Contract Documents

Contract Number: 201843656

General Sanitary – Cherry Creek Improvements

August 1, 2018

# CHERRY CREEK EAST SANITARY LINING - STEELE STREET AERIAL

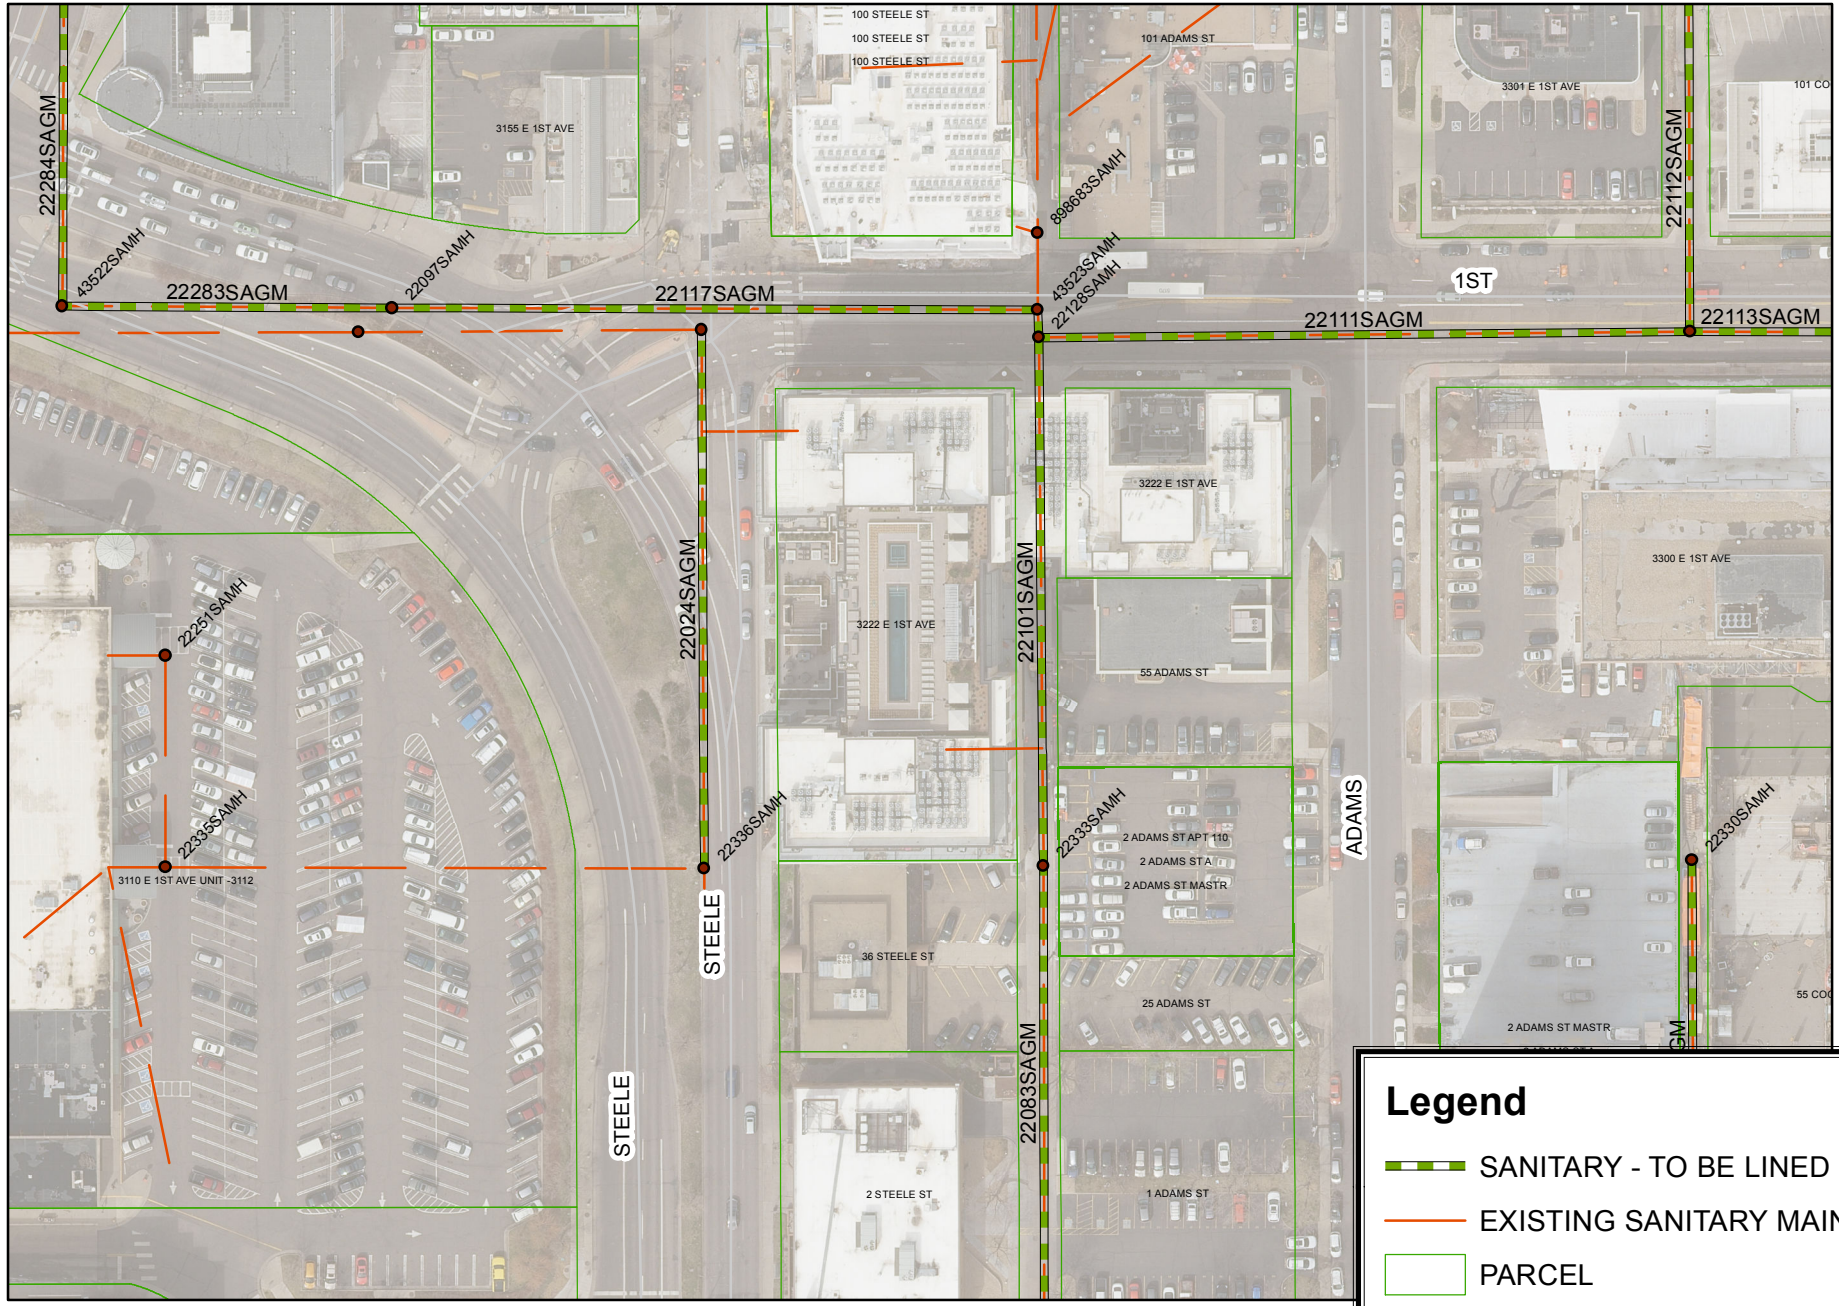
- Q2.** Map page #14: 1st & Steele intersection; could CCD provide a better satellite map location for MH22336 & MH43522?
- A2.** *A sketch of the aerial (Cherry Creek East Sanitary Lining – Steele Street Aerial.PDF) was provided at the Pre-bid and is appended to this Addendum.*
